# Intel<sup>®</sup> 815EP Chipset Platform

Design Guide Update

*April 2002*

Revision History .....	4
Preface.....	5
General Design Considerations .....	8
Schematic, Layout and Routing Updates.....	11
Documentation Changes .....	13

**Figure 47.a. CDC\_DN\_ENAB# Support Circuitry for a Single Codec on Motherboard**

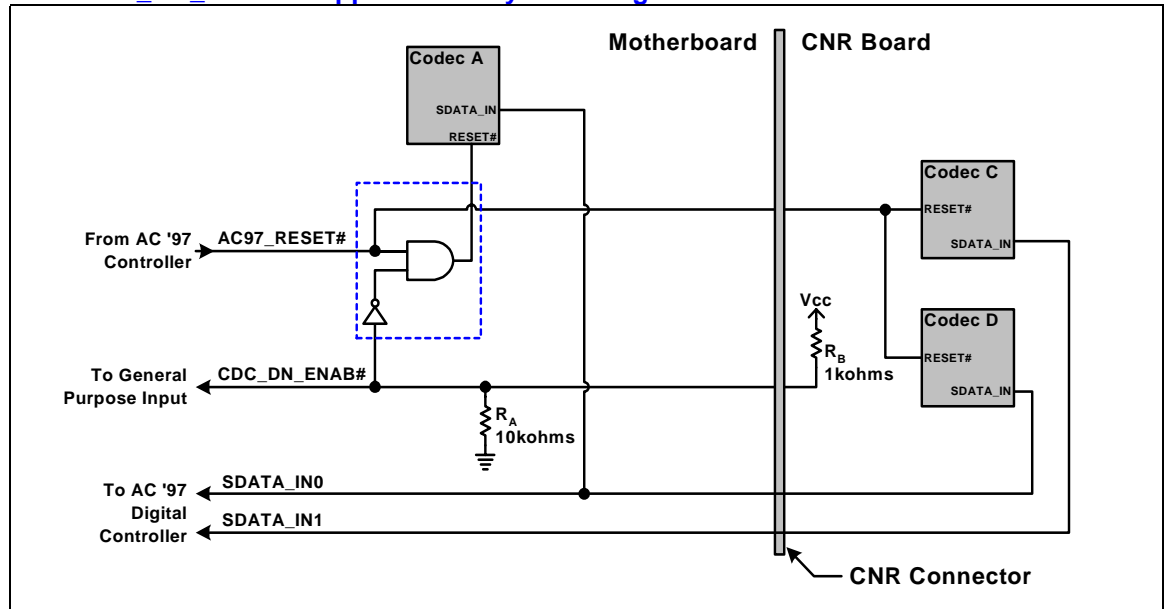
The following circuits (Figure 47.a., Figure 47.b, Figure 47.c., and Figure 47.d.) show the adaptability of a system with the modification of  $R_A$  and  $R_B$  combined with some basic glue logic to support multiple codec configurations. This also provides a mechanism to make sure that only two codecs are enabled in a given configuration and allows the configuration of the link to be determined by the BIOS so that the correct PnP IDs can be loaded.

As shown in Figure 47.a., when a single codec is located on the motherboard, the resistor  $R_A$  and the circuitry (AND and NOT gates) shown inside the dashed box must be implemented, on the motherboard. This circuitry is required in order to disable the motherboard codec when a CNR is installed which contains two AC '97 codecs (or a single AC '97 codec which must be the primary codec on the AC-Link).

1. While it is possible to disable down codex, as shown in Figure 47.a. and Figure 47.d., it is recommended against for reasons cited in the ICHx/AC'97 White Paper, including avoidance of shipping redundant and/or non-functional audio jacks.

2. All CNR designs include resistor  $R_B$ . The value of  $R_B$  is either 1 k $\Omega$  or 100 k $\Omega$ , depending on the intended functionality of the CNR (whether or not it intends to be the primary/controlling codec).

3. Any CNR with two codex must implement  $R_B$  with value 1 k $\Omega$ . If there is one codec, use a 100 k $\Omega$  pull-up resistor. A CNR with zero codex must not stuff  $R_B$ . If implemented,  $R_B$  must be connected to the same power well as the codec so that it is valid whenever the codec has power.

4. A motherboard with one or more codex down must implement  $R_A$  with a value of 10 k $\Omega$ .
5. The CDC\_DN\_ENAB# signal must be run to a GPI so that the BIOS can sense the state of the signal. CDC\_DN\_ENAB# is *required* to be connected to a GPI; a connection to a GPIO is *strongly recommended* for testing purposes.

Figure 47.b. CDC\_DN\_ENAB# Support Circuitry for Multi-Channel Audio Upgrade

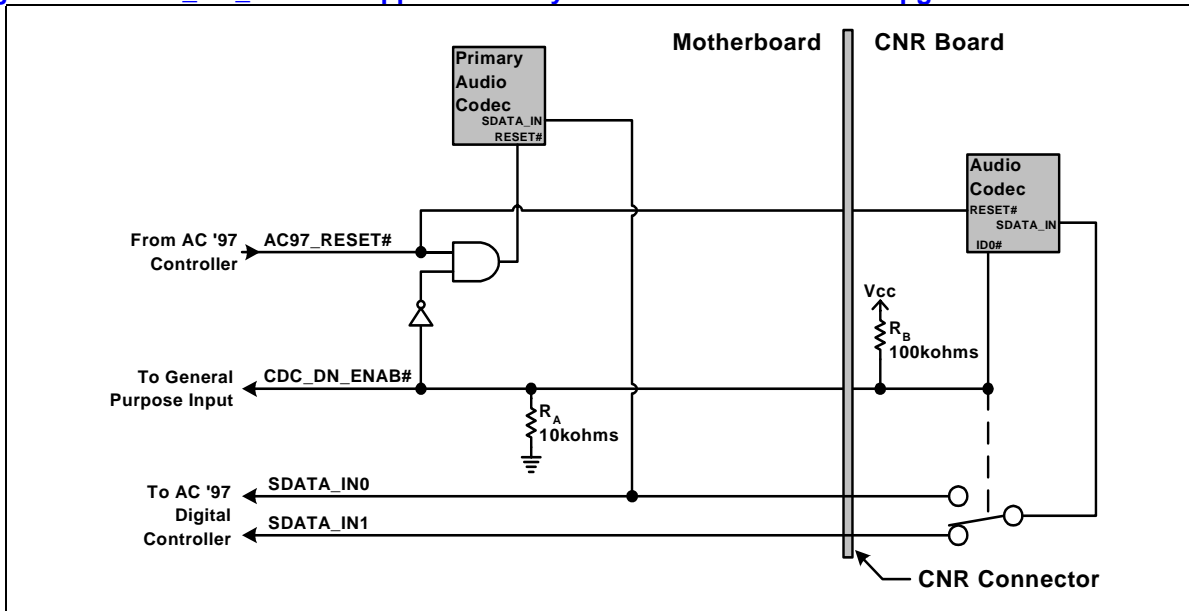
By installing resistor  $R_B$  (1 k $\Omega$ ) on the CNR, the codec on the motherboard becomes disabled (held in reset) and the codec(s) on the CNR take control of the AC-link. One possible example of using this architecture is a system integrator installing an audio plus modem CNR in a system already containing an audio codec on the motherboard. The audio codec on the motherboard would then be disabled, allowing all of the codecs on the CNR to be used.

The architecture shown in Figure 47.b. has some unique features. These include the possibility of the CNR being used as an upgrade to the existing audio features of the motherboard (by simply changing the value of resistor  $R_B$  on the CNR to 100 k $\Omega$ ). An example of one such upgrade is increasing from two-channel to four or six-channel audio.

Both Figure 47.b. and Figure 47.c. show a switch on the CNR board. This is necessary to connect the CNR board codec to the proper SDATA\_IN $n$  line as to not conflict with the motherboard codec(s).

Figure 47.c. CDC\_DN\_ENAB# Support Circuitry for Two-Codex on Motherboard / One-Codex on CNR

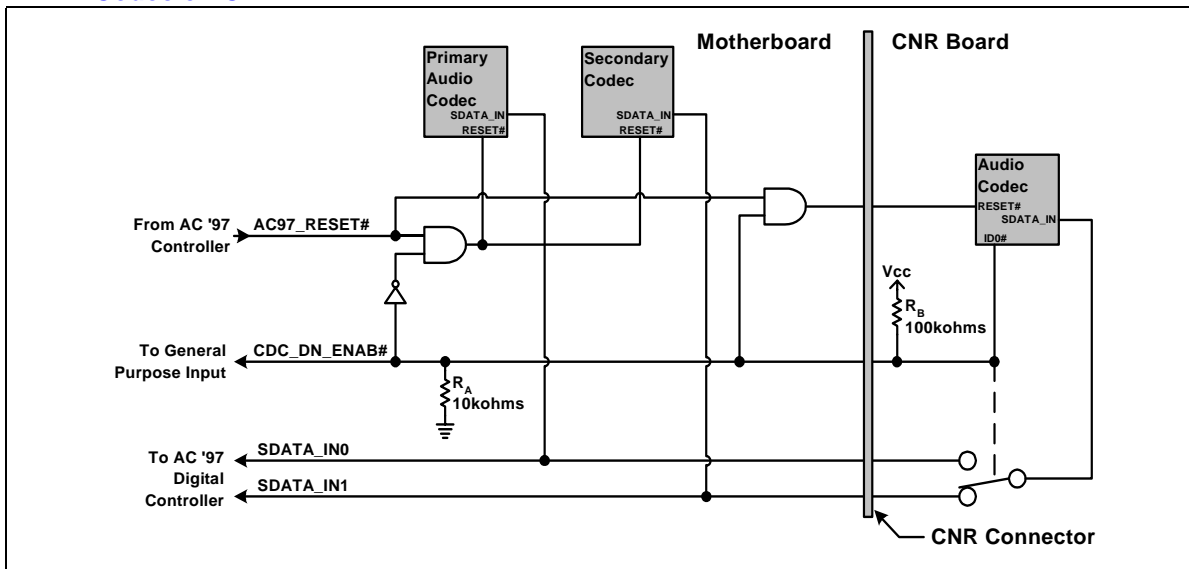
Figure 47.c. shows the circuitry required on the motherboard to support a two-codec down configuration. This circuitry disables the codec on a single codec CNR. Notice that in this configuration the resistor,  $R_B$ , has been changed to 100 k $\Omega$ .

**Figure 47.d. CDC\_DN\_ENAB# Support Circuitry for Two-Codex on Motherboard / Two-Codex on CNR**

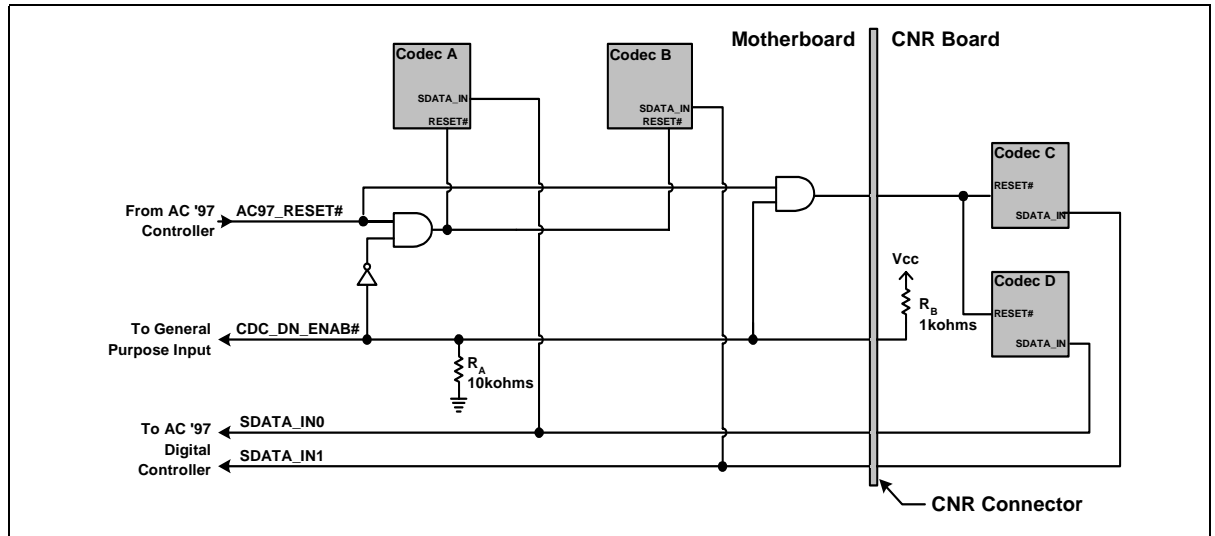
Figure 47.d. shows the case of two-codex down and a dual-codex CNR. In this case, both codex on the motherboard are disabled (while both on CNR are active) by  $R_A$  being 10 k $\Omega$  and  $R_B$  being 1 k $\Omega$ .

**Figure 77.a. Example 3.3V/V5REF Sequencing Circuitry**

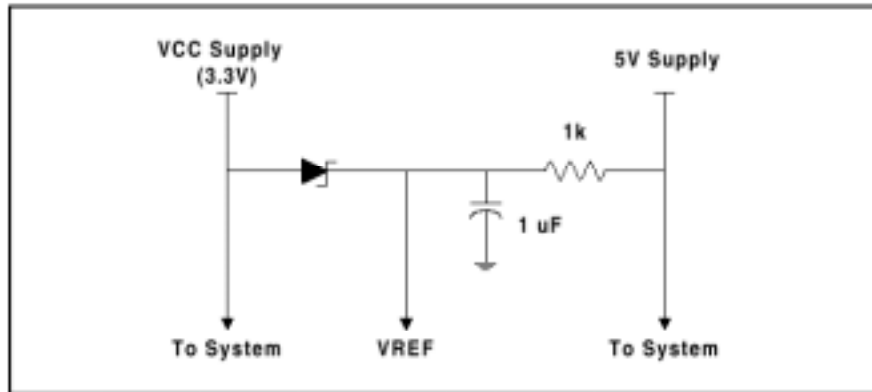
V5REF is the reference voltage for 5V tolerance on inputs to the ICH2. V5REF must be powered up before or simultaneously to VCC3\_3. It must also power down after or simultaneous to VCC3\_3. The rule must be followed in order to ensure the safety of the ICH2. If the rule is violated, internal diodes will attempt to draw power sufficient to damage the diodes from the VCC3\_3 rail. Figure 77.a. shows a sample implementation of how to satisfy the V5REF/3.3V sequencing rule.

This rule also applies to the stand-by rails, but in most platforms, the VccSus3\_3 rail is derived from the VccSus5 and therefore, the VccSus3\_3 rail will always come up after the VccSus5 rail. As a result,

V5REF\_Sus will always be powered up before VccSus3\_3. In platforms that do not derive the VccSus3\_3 rail from the VccSus5 rail, this rule must be comprehended in the platform design.

As an additional consideration, during suspend the only signals that are 5V tolerant are USB0C. If these signals are not needed during suspend, V5REF\_Sus can be hooked to the VccSus3\_3 rail.

V5REF is the reference voltage for 5 V tolerance on inputs to the ICH2. V5REF must be powered up before Vcc3\_3, or after Vcc3\_3 within 0.7 V. Also, V5REF must power down after Vcc3\_3, or before Vcc3\_3 within 0.7 V. The rule must be followed in order to ensure the safety

of the ICH2. If the rule is violated, internal diodes will attempt to draw power sufficient to damage the diodes from the Vcc3\_3 rail. Figure 77.a. shows a sample implementation of how to satisfy the V5REF/3.3V sequencing rule.

**Figure 72.1 FWH VPP Isolation Circuitry**

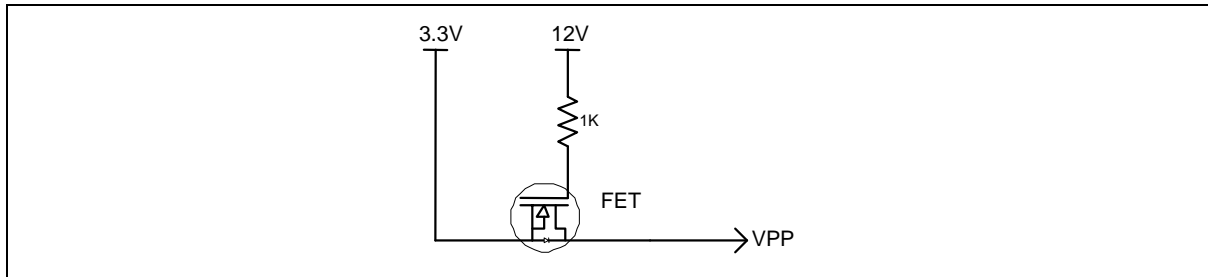
Section 9.12.2., *FWH Vpp Design Guidelines*, has the following paragraph and figure added as shown below:

In some instances, it is desirable to program the FWH during assembly with the device soldered down on the board. In order to decrease programming time it becomes necessary to apply 12 V to the V<sub>pp</sub> pin. The following circuit will allow testers to put 12 V on the V<sub>pp</sub> pin while keeping this voltage separated from the 3.3 V plane to which the rest of the power pins are connected. This circuit also allows the board to operate with 3.3 V on this pin during normal operation.

**Figure 64.1 : Intel® 82562ET/EM Disable Circuit**

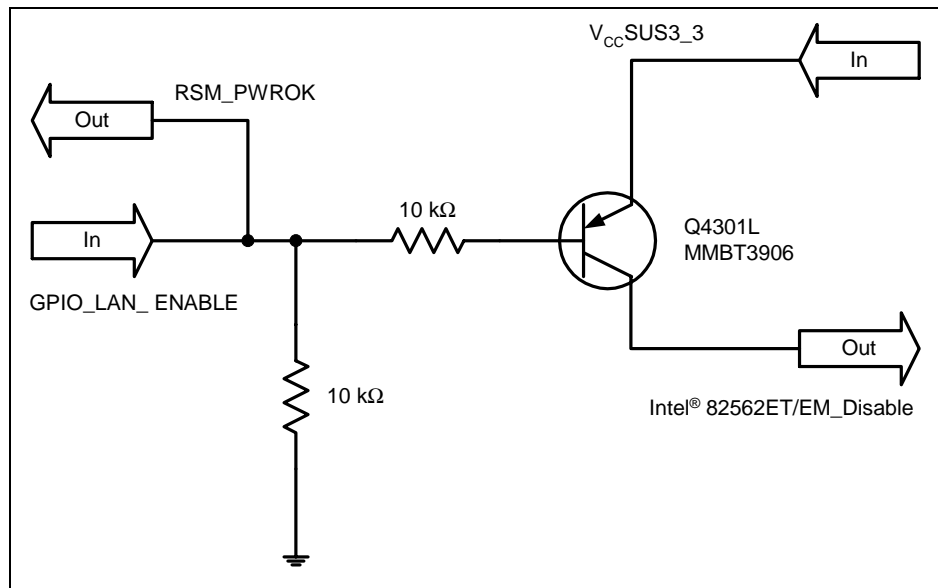
To disable the Intel 82562ET/EM, the device must be isolated (disabled) prior to reset (RSM\_PWROK) asserting. Using a GPIO, such as GPO28 to be LAN\_Enable (enabled high), LAN will default to enabled on initial power-up and after an AC power loss. This circuit shown below will allow this behavior. The BIOS, by controlling the GPIO, can disable the LAN microcontroller.

There are four pins which are used to put 82562ET/EM controller in different operating states: Test\_En, Isol\_Tck, Isol\_Ti, and Isol\_Tex. The table below describes the operational/disable features for this design.

The four control signals shown in the above table should be configured as follows: Test\_En should be pulled-down through a 100 Ω resistor. The remaining three control signals should each be connected through 100 Ω series resistors to the common node “82562ET/EM\_Disable” of the disable circuit.

**30. Changed: USB, Section 9.5; Modified**

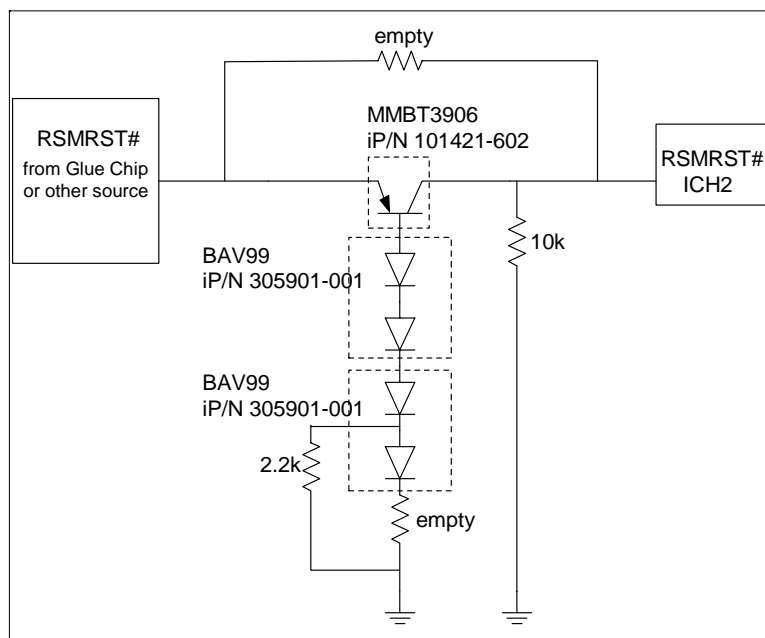
The third bullet in Section 9.5, *USB*, is changed to read as follows:

An optional cap (0 pF – 47pF) may be placed as close to the USB connector side of the series resistors on the USB data lines (P0+/-, P1+/-, P2+/-, P3+/-). This cap should be sized to minimize EMI radiation while still maintaining signal quality (rise/fall time, Vcrs, etc.).

Figure 72. Power Delivery Map

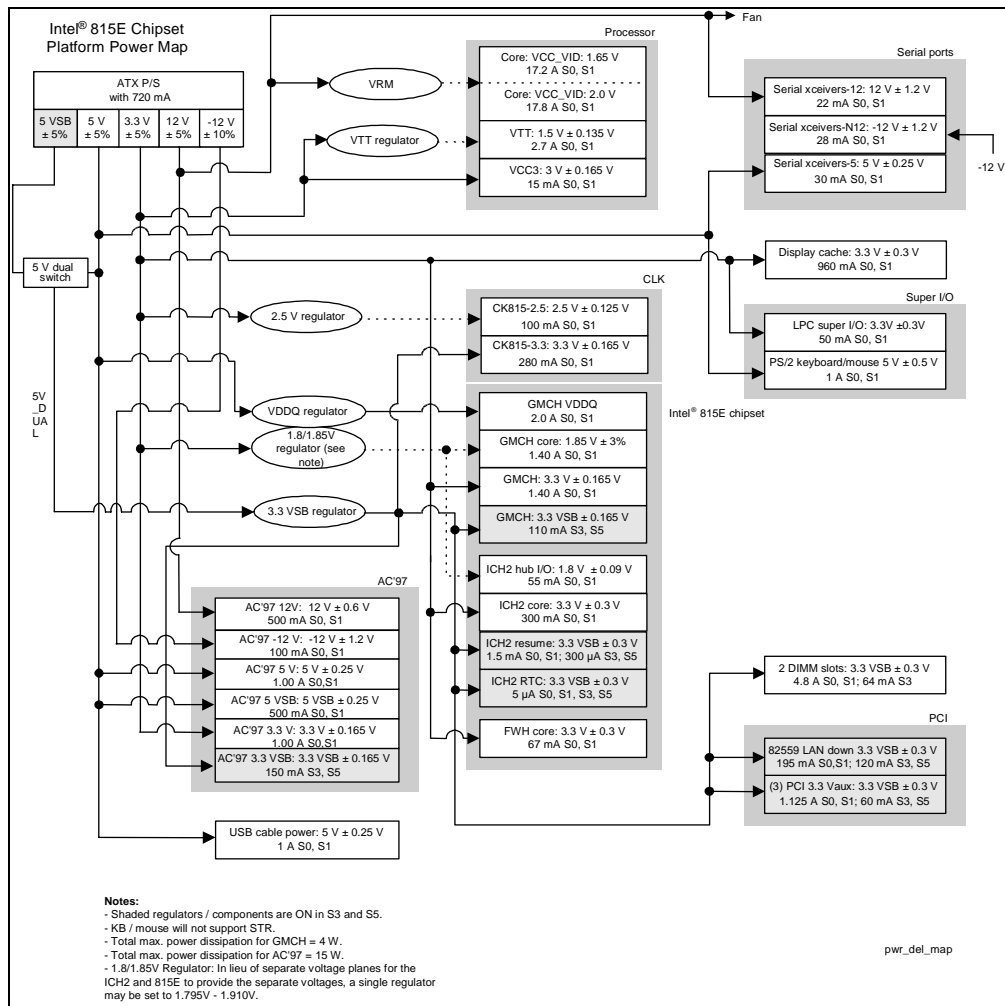
### 35. Replaced Figure 72, Power Delivery Map

Figure 72, Power Delivery Map, is replaced with the following:

Figure 72, Power Delivery Map, in Section 11, *Power Delivery*, was replaced by Document Change #35 in the public *Intel® 815EP Chipset Platform Design Guide Update 290717-002*, dated February 2002. Figure 72 has two additional changes in the ICH2 section.

(1) One ICH2 power plane is added to it. This added ICH2 power plane is “ICH2 V5REF\_SUS”. This power plane has always existed in the ICH2. It is not new. This addition to the Power Delivery Map simply shows this ICH2 plane.

(2) The block labeled “ICH2 5V” is renamed to “ICH2 V5REF”.

1.85 V core and mixed 3.3 V, 1.5 V, and AGTL+ IO. Note that the 82801BA ICH2 has a 1.8 V requirement and the 82815EP MCH has a 1.85 V requirement. Instead of separate voltage regulators to meet these requirements, a single voltage regulator can be set to 1.79 5V to 1.910V. See Figure 72, the *Power Delivery Map*.

**40. Changed Figure 59, Trace Routing, in Section 9.11.2.1, General Trace Routing Considerations**

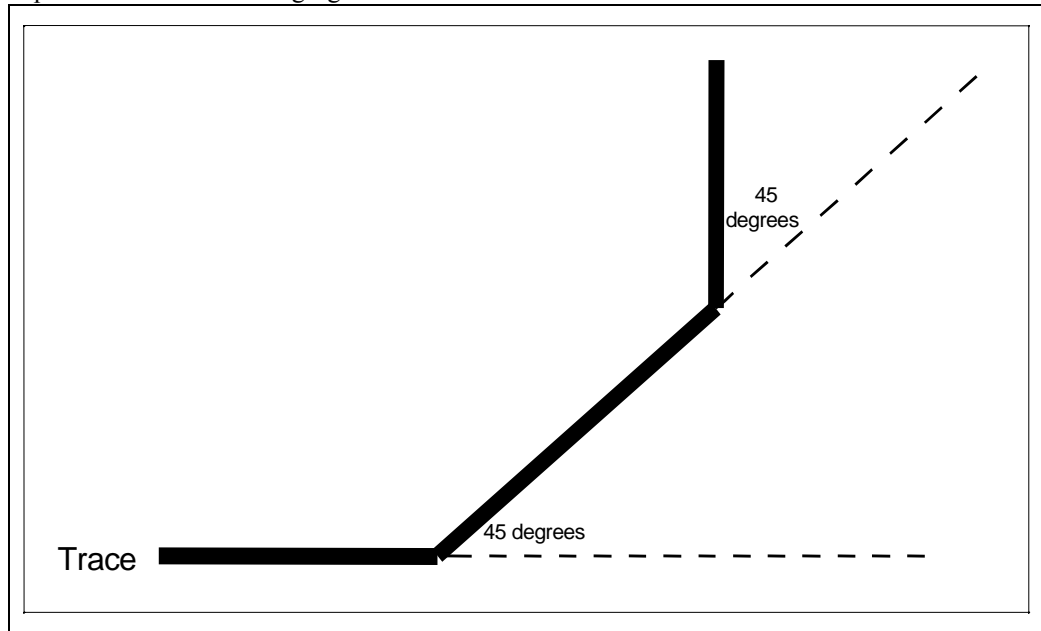
Figure 59, Trace Routing, in Section 9.11.2.1, *General Trace Routing Considerations*, is replaced with the following figure:

For high-speed signals, the number of corners and vias should be kept to a minimum. If a 90° bend is required, it is recommended to use two 45 degree bends instead. Refer to Figure 59, *Trace Routing*.
